NEDO-21052-A  
75NED53  
CLASS I  
MAY 1979

# MAXIMUM DISCHARGE RATE OF LIQUID-VAPOR MIXTURES FROM VESSELS

This approved version of report NEDO-21052 (September 1975) is being provided in accordance with the NRC's topical report program. This report NEDO-21052-A consists of the original text of NEDO-21052, the NRC staff letter accepting this report as a reference, the NRC staff Topical Report Evaluation and the supplementary information General Electric provided to the NRC staff during the review of NEDO-21052.

SUBJECT: REVIEW OF GENERAL ELECTRIC TOPICAL REPORT NEDO-21052,  
 "MAXIMUM DISCHARGE RATE OF LIQUID-VAPOR MIXTURES FROM  
 VESSELS"

FIG.9 INTEGRATED ENERGY RELEASE

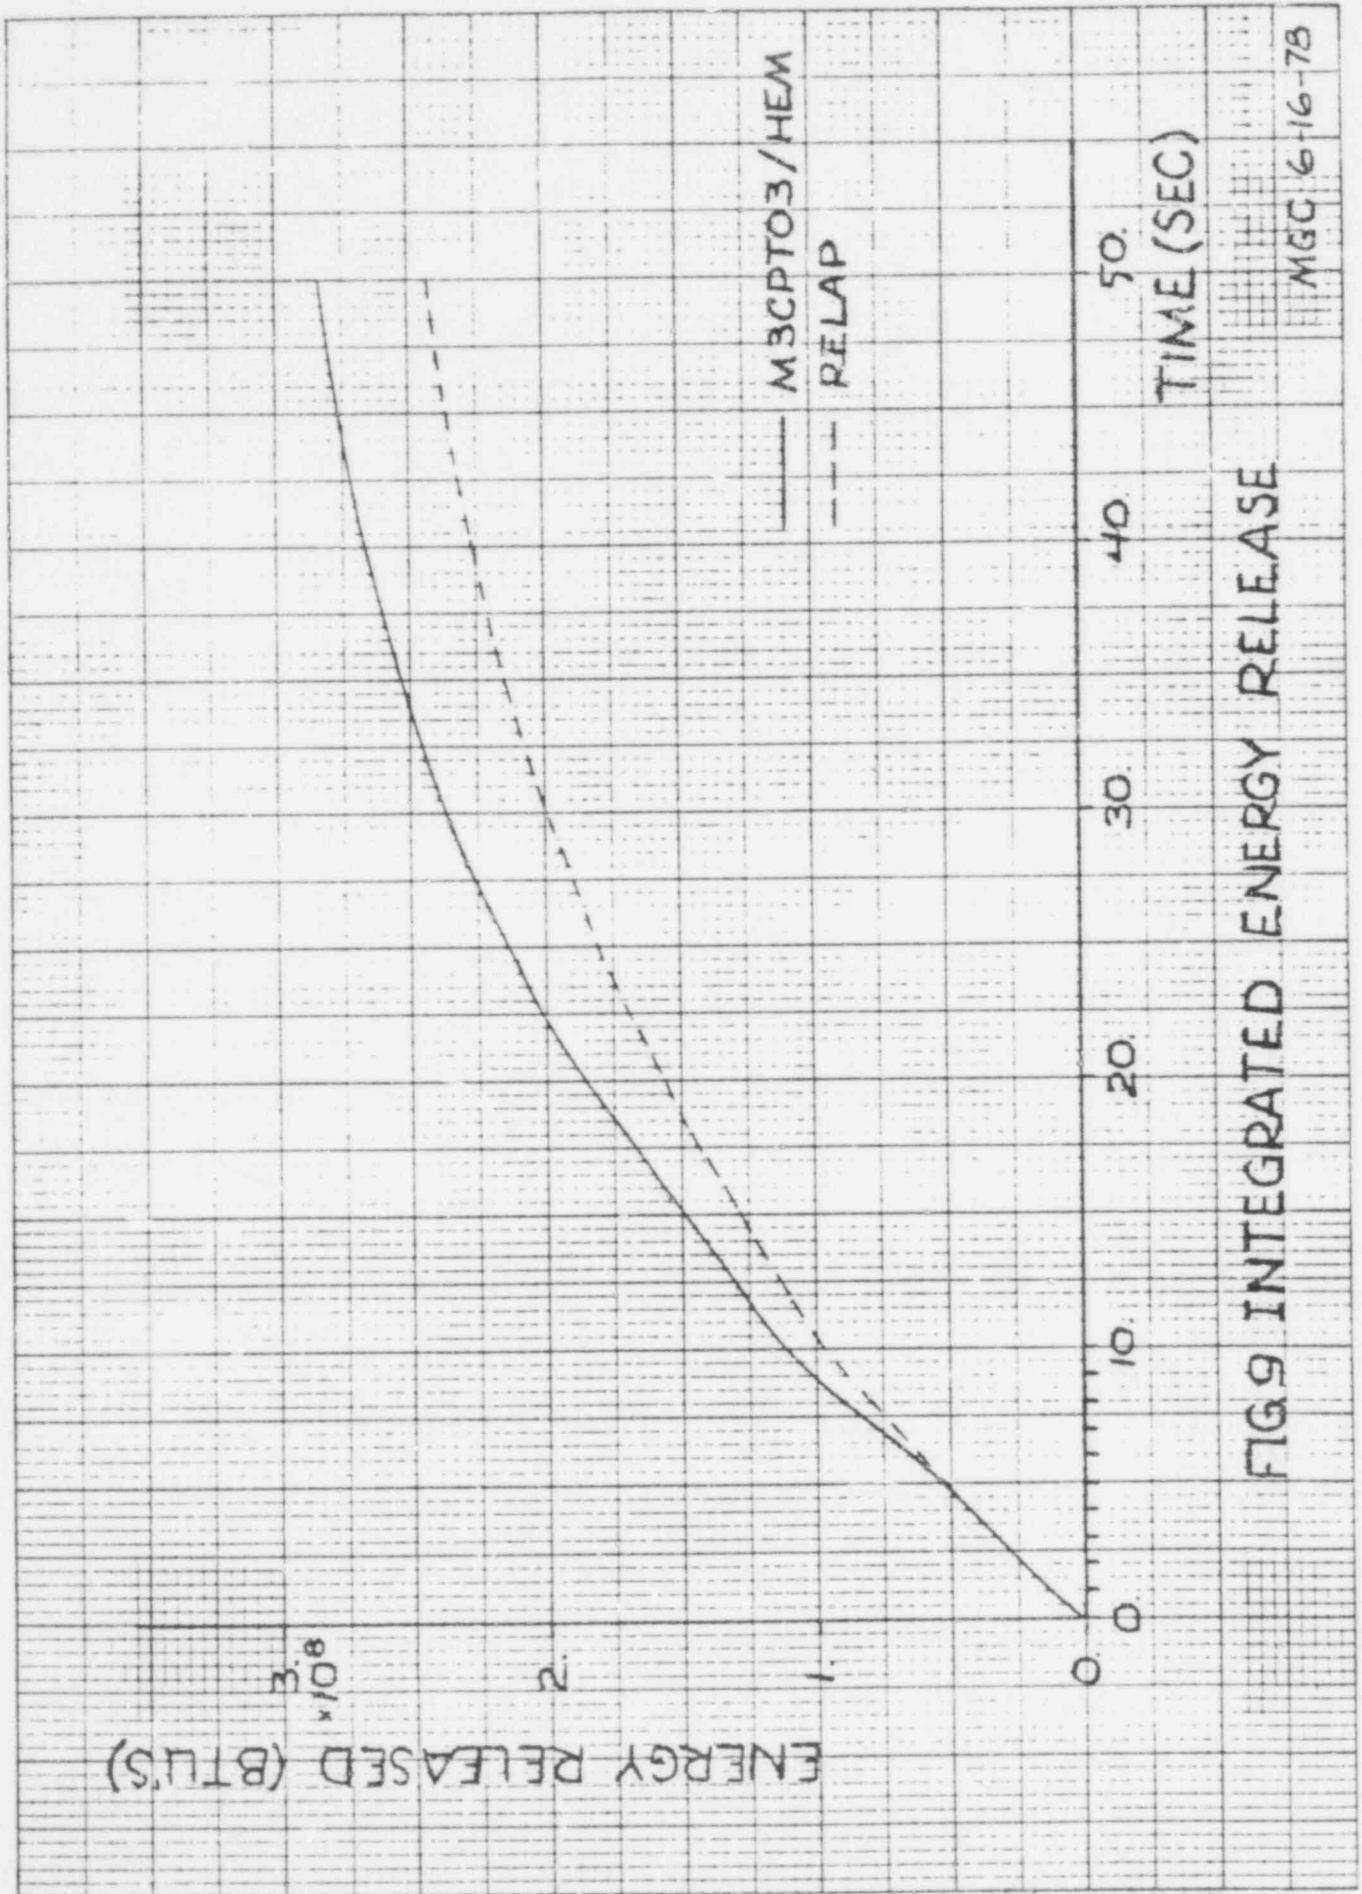
The mass release rates and the corresponding break fluid specific enthalpies given in Figures 2 through 5 for RELAP and given in Figures 6 and 7 for M3CPT03/HEM were integrated and the results are shown in Figures 8 and 9. The results show that the total energy release calculated by M3CPT03 is approximately 17 percent higher than the total energy release calculated by the RELAP code. The integrated mass release rates are  $4.71 \times 10^5$  lbm for M3CPT03 and  $4.08 \times 10^5$  lbm for RELAP. The energies that would be released to the primary containment over 50 seconds are  $2.84 \times 10^8$  BTUs for M3CPT03 and  $2.43 \times 10^8$  BTUs for RELAP.

**FIGURE 2**  
 Correlation of Data Assuming Choking  
 at Exit of Test Section  
 (E = 421 to 425 Btu/lb)

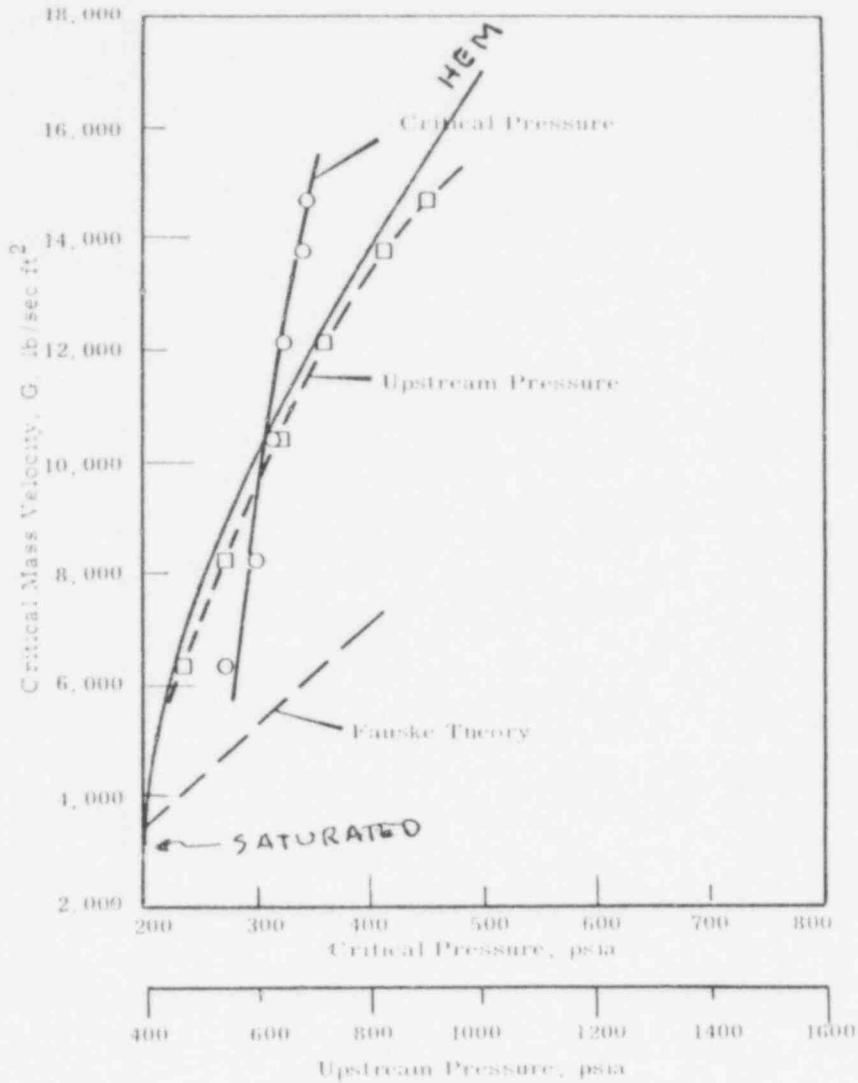
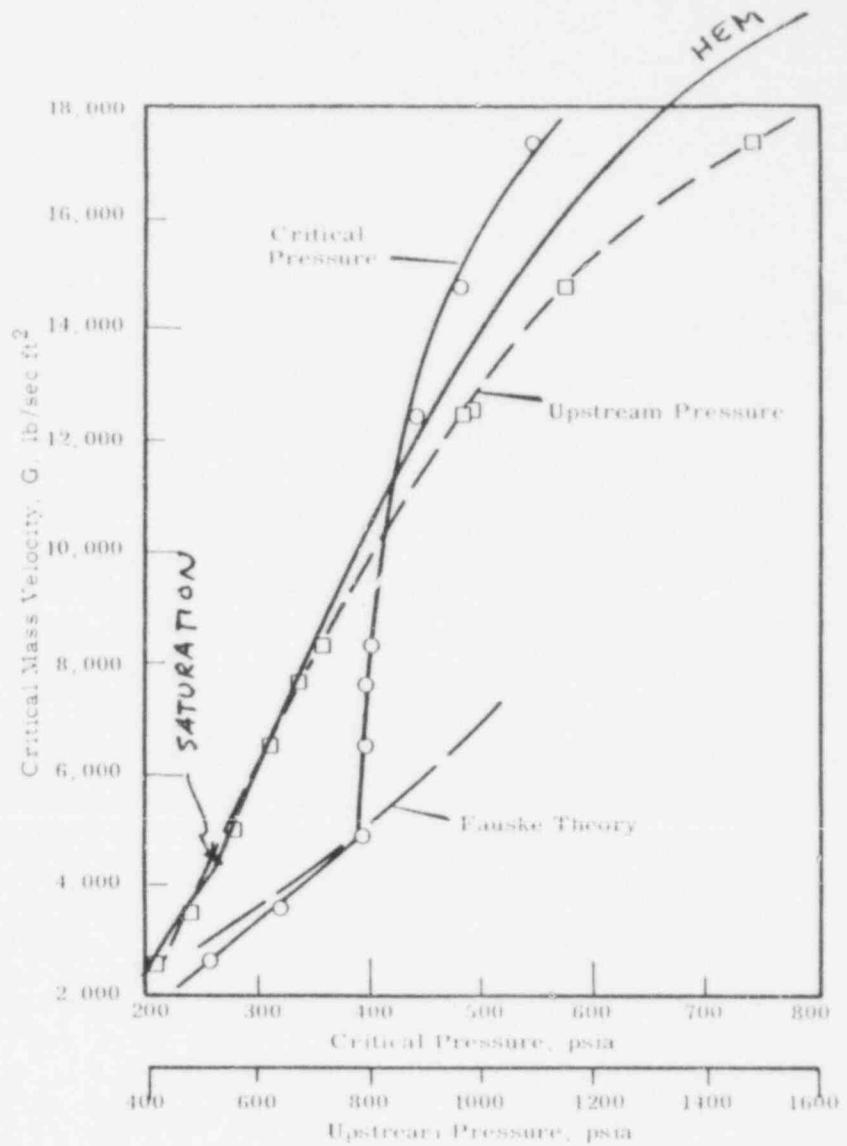
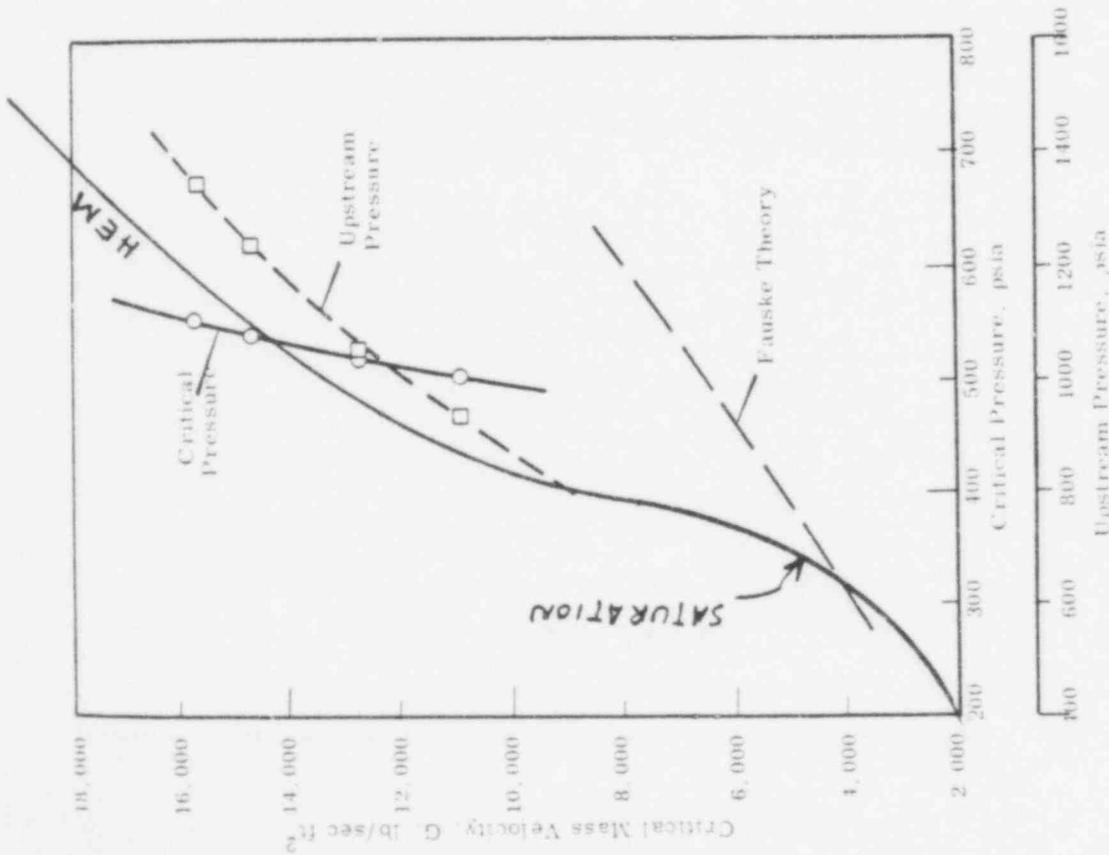
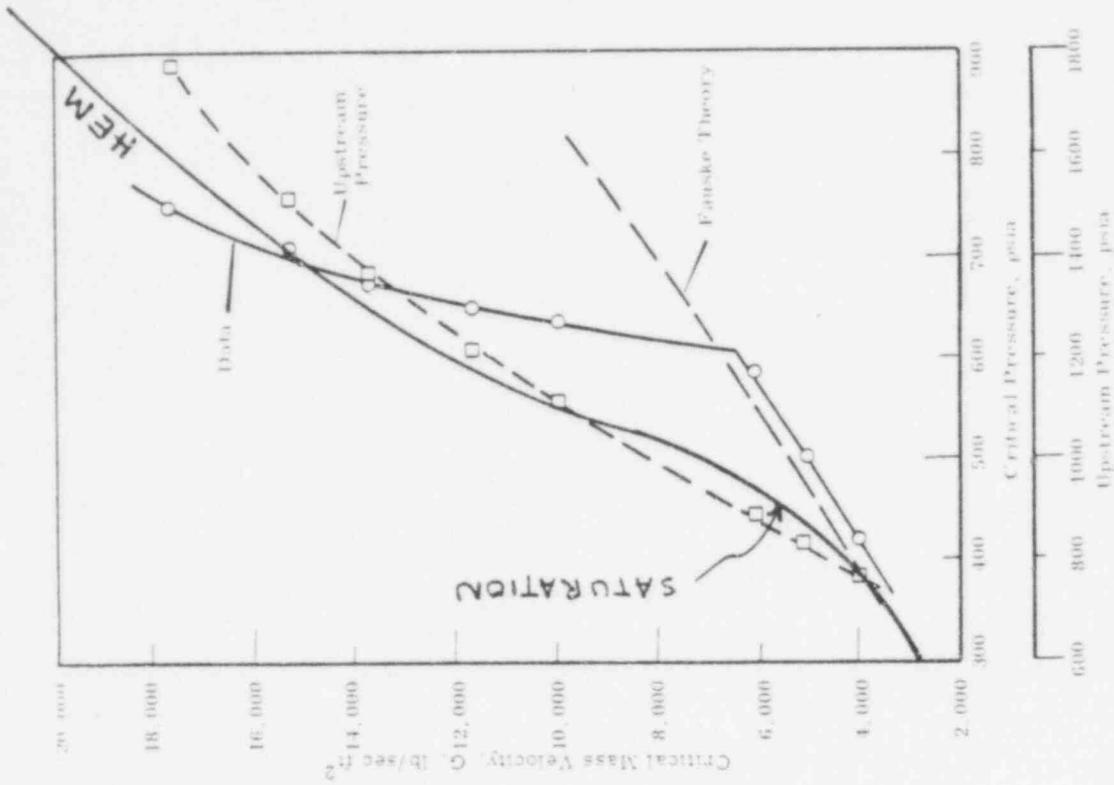
The particular Zaloudek data, Figures 2 through 5 of HW-80535 is attached. The solid curve labeled HEM was obtained from Figure 1 in NEDO-21052, employing the values of stagnation enthalpy and upstream (stagnation) pressure given.

It is seen that the HEM gives accurate predictions of all the data presented for both saturated and subcooled stagnation states.
